TENNESSEE VALLEY AUTHORITY

BROWNS FERRY NUCLEAR PLANT (BFN) - RESPONSE TO INQUIRY BY NRC STAFF CONCERNING THE DISPOSITION OF WELD NUMBER DSRHR-2-5A AS A RESULT OF RADIOGRAPH INDICATIONS

NOI No. U2/C5-135

Component ID DSRHR 2-5A

← DSRHR-2-5A

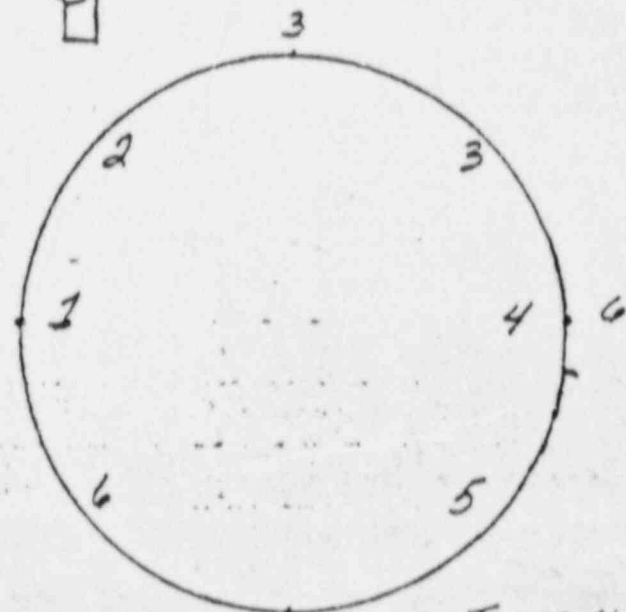
Linear Inclusion Indications exceeding Allowable Code Limit 0.2 inches below the ND Surface
on spool piece side. Indications are a cumulative length of 6.25 inches in R.T. Film.

Upon reexamining Weldment No. DSRHR-2-5A with the more sensitive "M-Film", an additional linear indication was discovered. Examination of sector 2-3 netted small indications while sectors 3-4 and 4-5 revealed defects of a larger nature. These indications appear to be a singular anomaly running intermittently for 45 inches in the circumferential direction on the upstream fusion wall.

Upon reexamining weldment No. DSRHR-2-5A with the more sensitive "M-FILM", AN ADDITIONAL linear indication was discovered. EXAMINATION OF sector 2-3 netted small indications while sectors 3-4 AND 4-5 revealed defects of A larger nature. These indications appear to be A singular anomaly running intermittently for 45 inches in the circumferential direction ON the UPPER FUSION WALL.

In conclusion, weld DSRHR-2-5A was found to be acceptable for continued operation without repair because of the nature of the indications. The indications were determined to be caused by lack of fusion between weld layers and not IGSCC. Because the indications have no appreciable through wall depth they are not considered to be a threat to the piping integrity.
